SuDS and Drainage Report

Nesltd, Land to south of The Black Horse Pub, Binstead Farm, Binstead Lane,
Walberton BN18 0LP

Rev: 3

9.6 **Appendix F – Previous Application Comments and Responses:**

CLIENT	BINSTEAD FARMS LTD				
ARCHITECT	SIMON HARVEY DESIGNS LTD				
JOB TITLE	NESTLED, LAND ADJ BINSTEAD LANE BINSTEAD, ARUNDEL				
DRAWING TITLE	DRAINAGE DESIGN				
DRAWN	LH	ENGINEER	C SLADE	CHECKED	CS
DATE	JAN 2026		SCALE @ A1	1:200	
JOB No.	C3944	STATUS	DRAWING No.	101	REV.
		PL			3

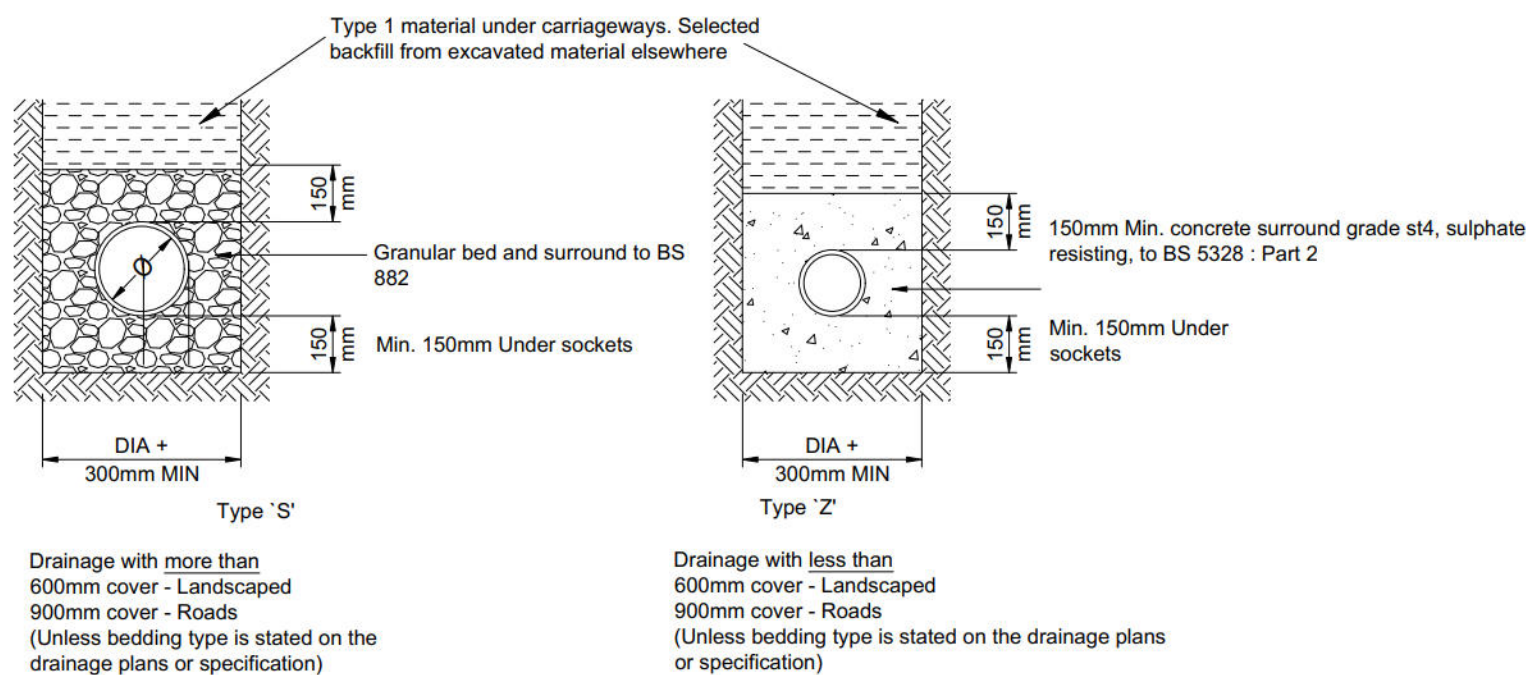
- 1.4 Sections through the proposed SuDS features and the outfall have not been provided and it is unclear how the proposed permeable paving will connect to the piped section of the proposed drainage system. [Parking area no longer permeable. Runoff will discharge into a filter strip](#)

- 4.2 It is noted that the orifice flow control has a diameter of 31mm. Whilst this will need to be reviewed once the correct discharge rate has been established, the risk of a blockage of the flow control must be considered and mitigated. [Risk of blockage is negligible. Inclusion of filters within the rainwater harvesting tanks, silt traps and the detention basin will reduce risk of blockages within the orifice chamber. The orifice chamber itself also has a trash screen built in. Regular maintenance will ensure that the system remains free of debris that may cause blockages.](#)

3	15.07.28	REMOVED PERMEABLE PARKING AREA AND INCLUDED FILTER STRIP	LH	CS	CS
2	24.06.26	REVISED TO SUIT TOPO SURVEY	LH	CS	CS
P-	30.03.26	PRELIMINARY ISSUE	LH	CS	CS
REV	DATE	DESCRIPTION	BY	CHK	APP

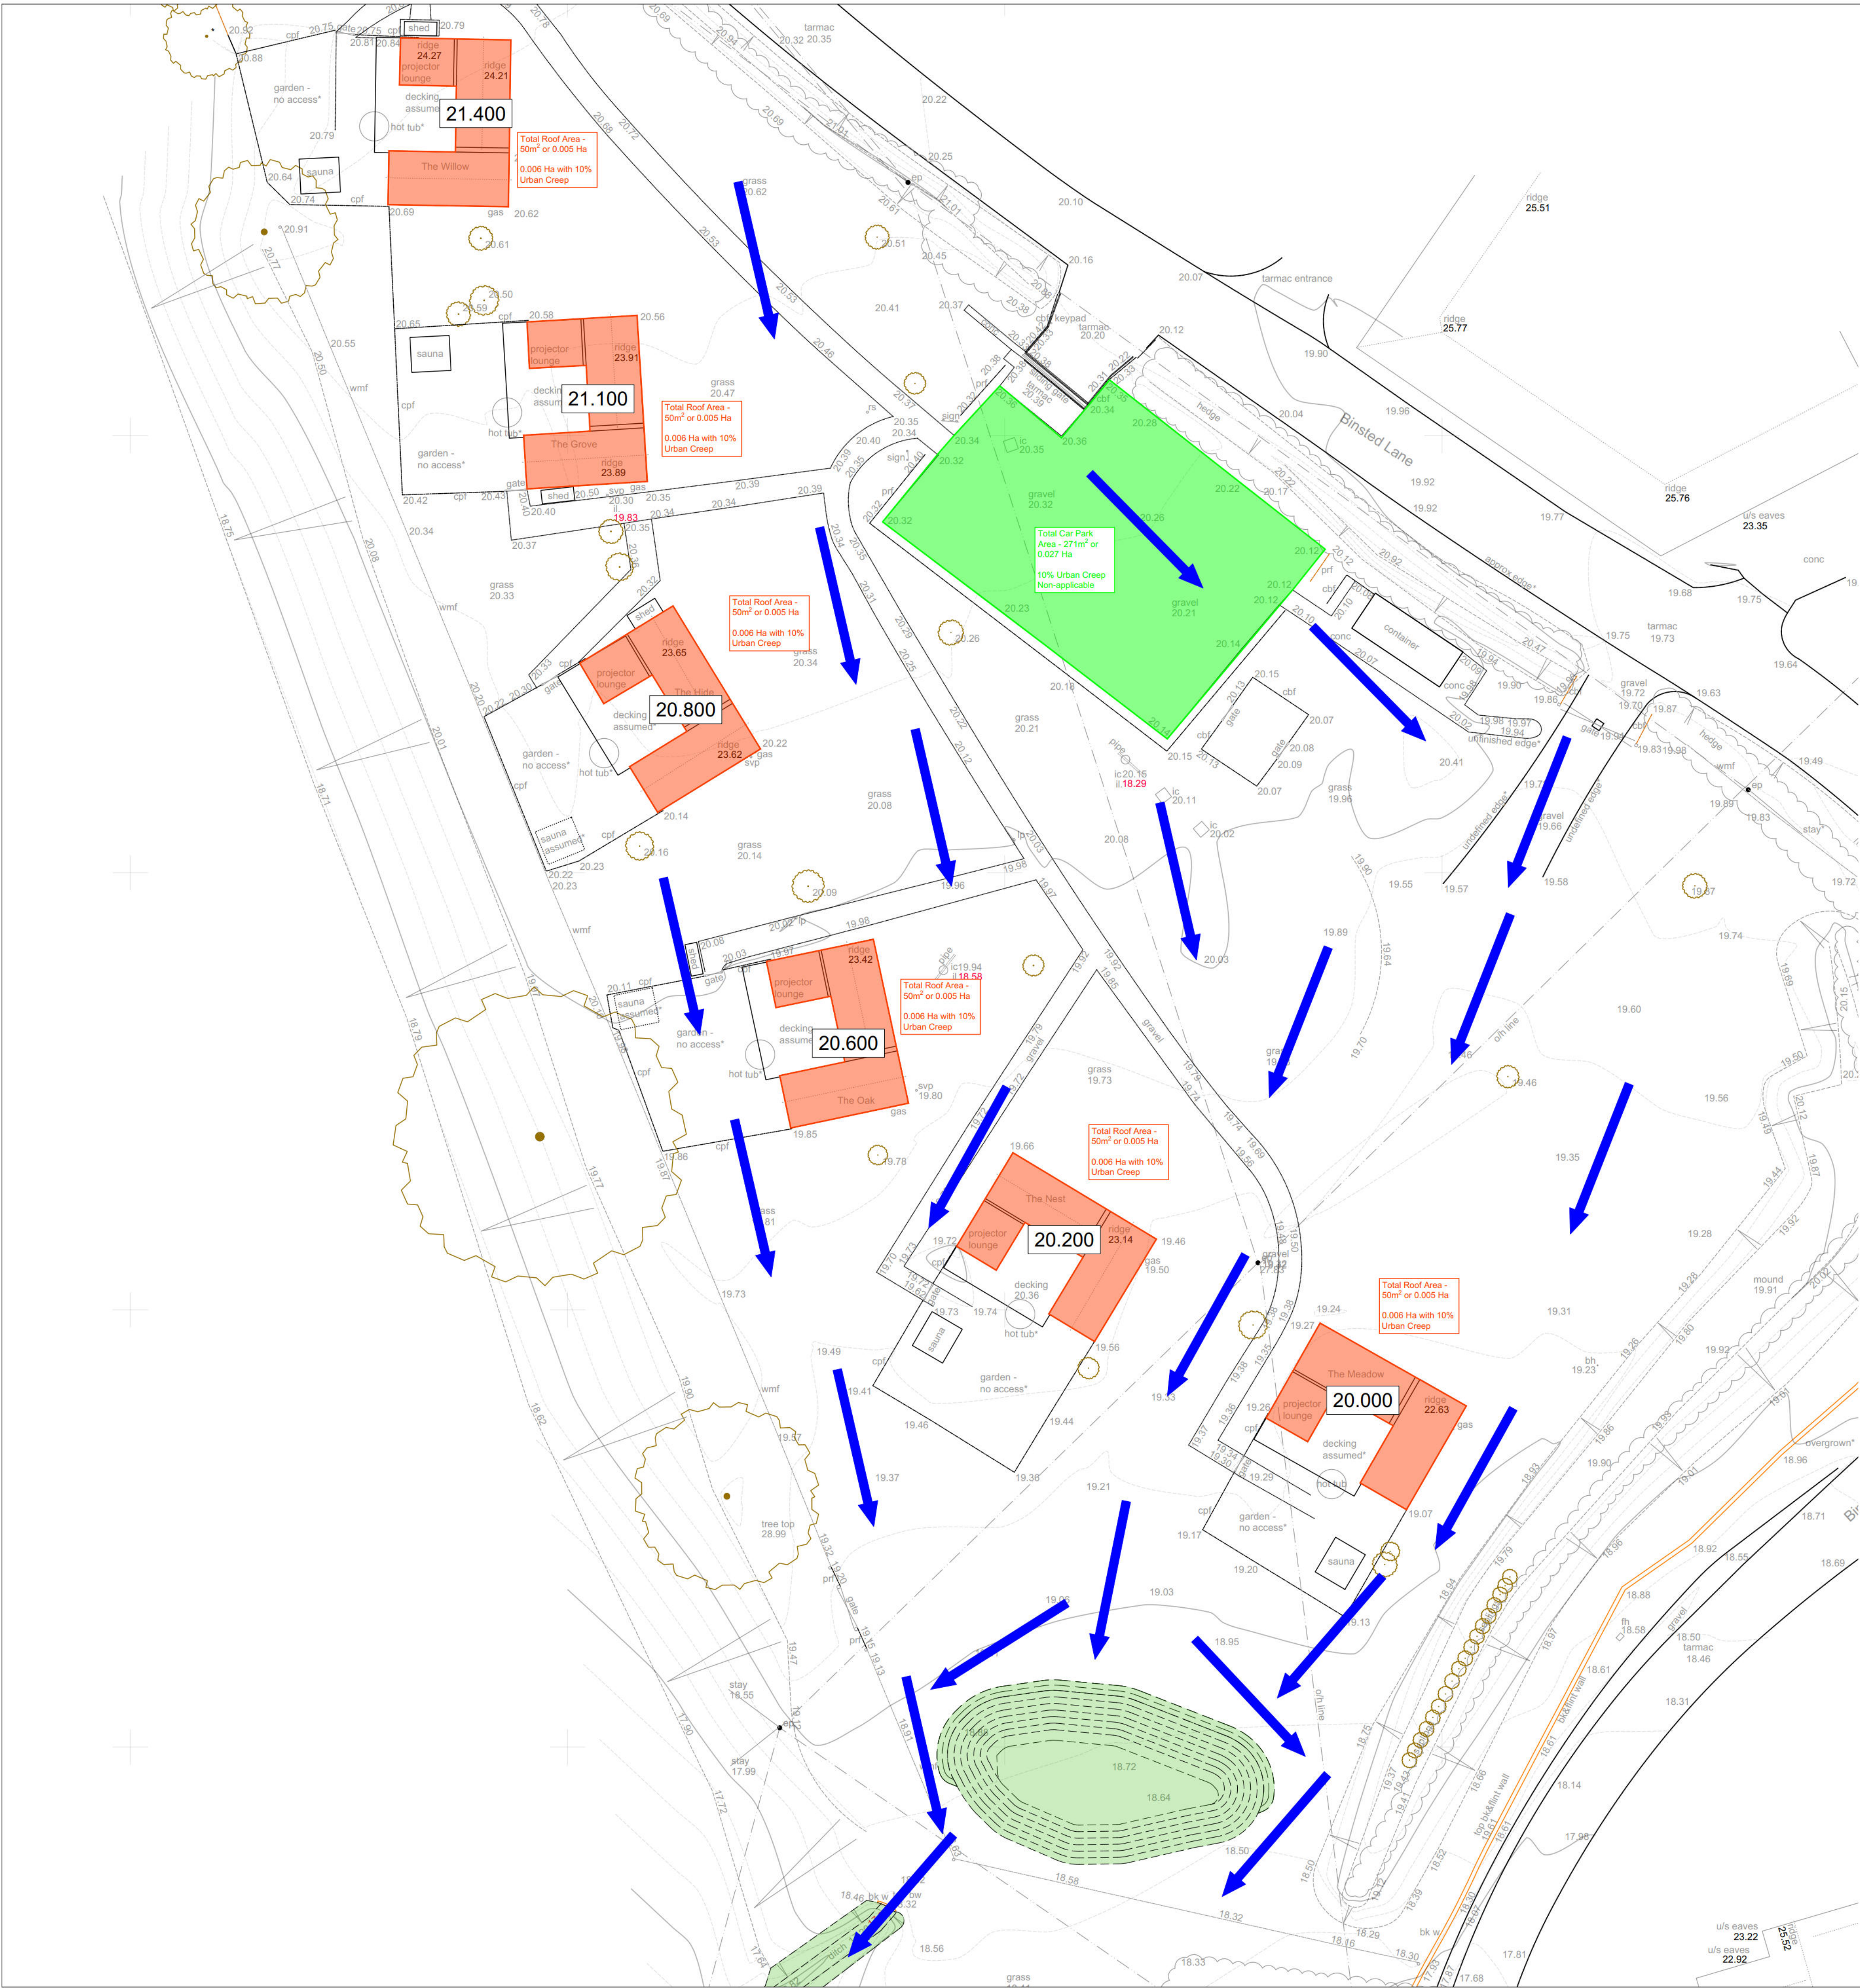
- 1.7 CGS Drawing 401 refers to an infiltration basin, this conflicts with the drainage strategy. [Adjusted to suit.](#)

- 4.3 The exceedance flow routing appears to pass over the area where the proposed basin is located. Information should be provided demonstrating that exceedance flows (including from elsewhere) are conveyed safely around or through the site without compromising the SuDS system. [Bunding has been included along the northern boundary of the detention basin to divert exceedance flows away. This is indicated within drawing C3944_401.](#)
- 4.4 The calculations do not include any allowance for surcharging of the outfall. [Adjusted to suit](#)
- 4.5 The submitted calculations do not include 50%AEP. [Included](#)
- 4.6 The FEH Point descriptor file should be emailed to land.drainage@arun.gov.uk [This will be emailed across.](#)
